Access Compliance Report Public Rights-of-Way (Curb Ramps)

Main Street: BLUEBERRY_WAY		Cross Street: CHIRPING_SPARROW_WAY		Location:	SW
ADA ID: RPAT211008123720	Ramp Type: Type 4 - Parallel	Initial Pass/Fail: Fail	Overall Compliance: No	Severity Score:	2
Codes/Mitigation Info/Possible Solution			Field Measurements/Component Compliance

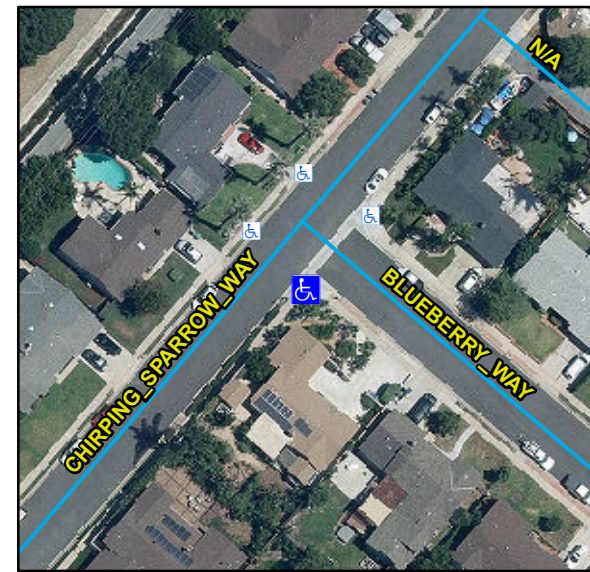
Compliance	Description	Data	Compliance	Description	Data
N/A	Ramp Length LT (in)	114	N/A	Ramp Length RT (in)	85
Yes	Ramp Width LT (in)	72	Yes	Ramp Width RT (in)	72
Yes	Ramp Run Slope LT (%)	6.6	Yes	Ramp Run Slope RT (%)	3.9
Yes	Ramp Cross Slope LT (%)	0.4	No	Ramp Cross Slope RT (%)	3.3
N/A	Landing Present	N/A	N/A	DWS Provided	N/A
N/A	Landing Length (in)	N/A	N/A	DWS Contrast	N/A
N/A	Landing Width (in)	N/A	N/A	DWS Length (in)	N/A
N/A	Landing Run Slope (%)	N/A	N/A	DWS Full Width	N/A
N/A	Landing Cross Slope (%)	N/A		DWS Offset Type	N/A
N/A	Landing Movement Obstructed?	N/A	N/A	DWS Offset Left (in)	N/A
	Landing Movement Type	N/A	N/A	DWS Offset Right (in)	N/A
N/A	Landing Shared	N/A			
N/A	Clear Space	Yes			
N/A	Clear Space To Crosswalk (in)	N/A			
N/A	Marked Crosswalk 1	No	N/A	Marked Crosswalk 2	No
	Crossing 1 Direction	E		Crossing 2 Direction	N
N/A	Marked Crosswalk 1 Width (in)	N/A		Marked Crosswalk 2 Width (in)	N/A

Remove & Replace Curb Ramp With Two New Directional Ramps or Equivalent.
